UNITED STATES PATENT AND TRADEMARK OFFICE

APPLICATION NO.	FILING DATE	FIRST NAMED INVENTOR	ATTORNEY DOCKET NO.	CONFIRMATION NO.
10/540,380	06/23/2005	Isador H Lieberman	CCF-6389PCT2/US	2534

Office Action Summary

Figure 1

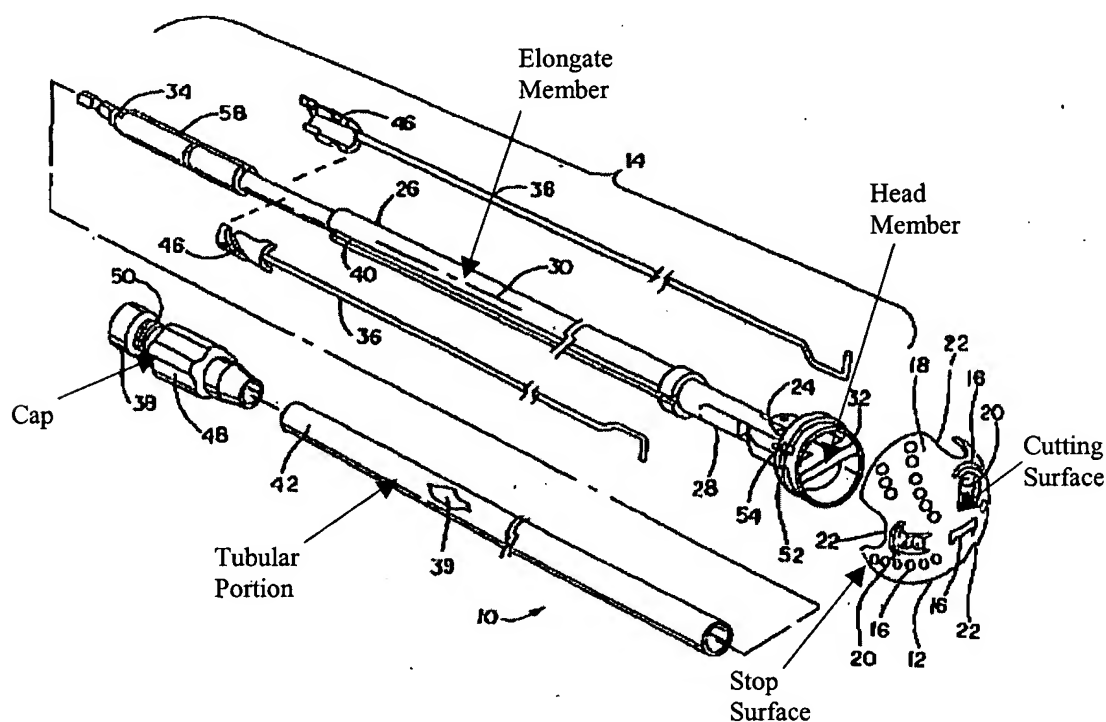
Regarding claims 1 and 8, Wolford discloses a device comprising an elongate member that includes a tubular portion extending between a proximal end and a distal end of the elongate member (reference Figure 1 below). The distal portion includes an articulating head section that has at least one stop surface and pivots about an axis transverse to the central axis of the elongate member. Wolford also discloses the device to comprise a means for articulating the head section. Regarding claims 2 and 9, Wolford discloses a device further comprising a shaft member connected to the head section and extending coaxially within the tubular section. The shaft member and head section are axially moveable relative to the tubular section. Regarding claims 3 and 10, Wolford further discloses a device comprising a terminal end portion that projects beyond the proximal end of the elongate member. Regarding claims 4 and 11, Wolford

discloses a device further comprising a cap member that is removably attached to the terminal end of the shaft member. The cap member further comprises a first surface that can engage the proximal portion of the elongate member and a second surface opposite the first able to receive repetitive impacts.
